CITY OF ALBUQUERQUE

Re: Car wash Vacuum 500 Coors Blvd. NW

Traffic Circulation Layout

A1.0

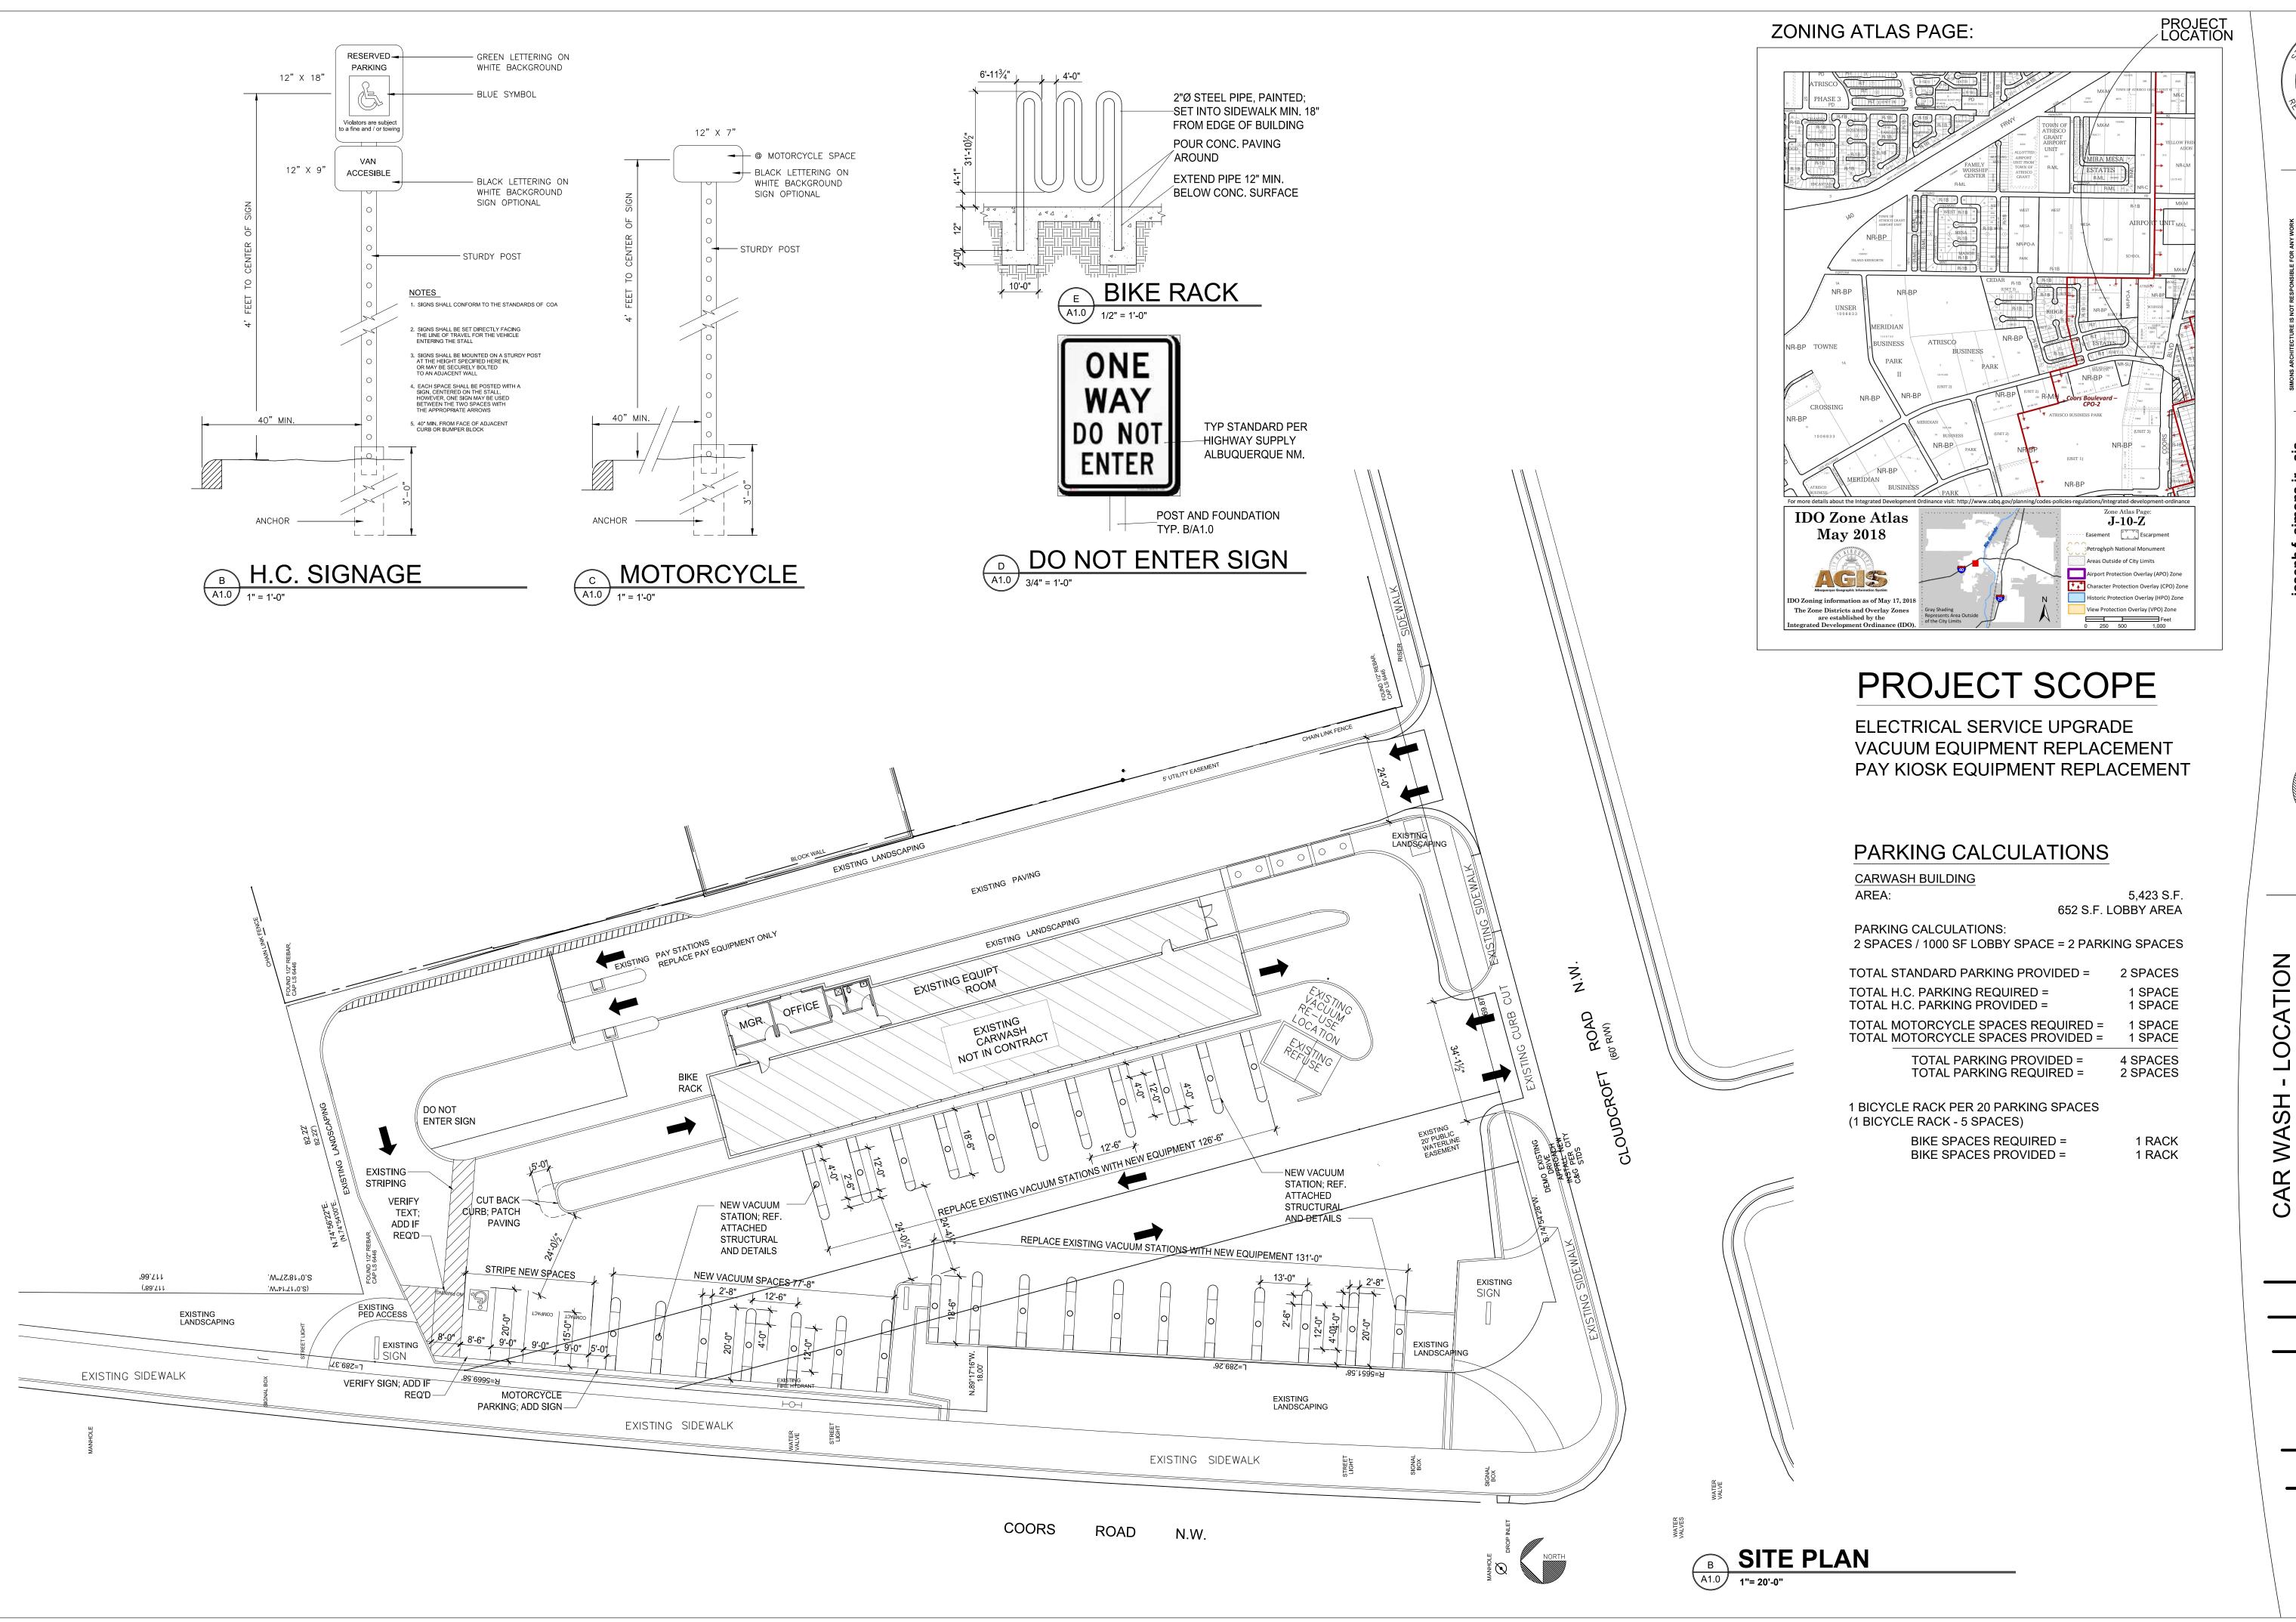
- The ADA accessible parking sign must have the required language per 66-7-352.4C NMSA 1978 "Violators Are Subject to a Fine and/or Towing." Please call out detail and location of HC signs.
- Note stating existing curb cut and note stating demo existing curb cut. Please clarify.
- 3. New curb cut not to exceed 30'. Extend landscaping west towards Coors Blvd.
- 4. Please specify the City Standard Drawing Number when applicable.
- 5. Indicate ramps and truncated domes on both access entrances and exits.
- List radii for all curves shown; for passenger vehicles, the minimum end island radius for passenger vehicles is 15 ft. Radius for delivery trucks, fire trucks, etc. is 25 ft. or larger.
- Where replacing existing vacuum stations fronting Coors. Google image shows 8 vacuum stations. TCL plan indicates 10 vacuum stations, please clarify.
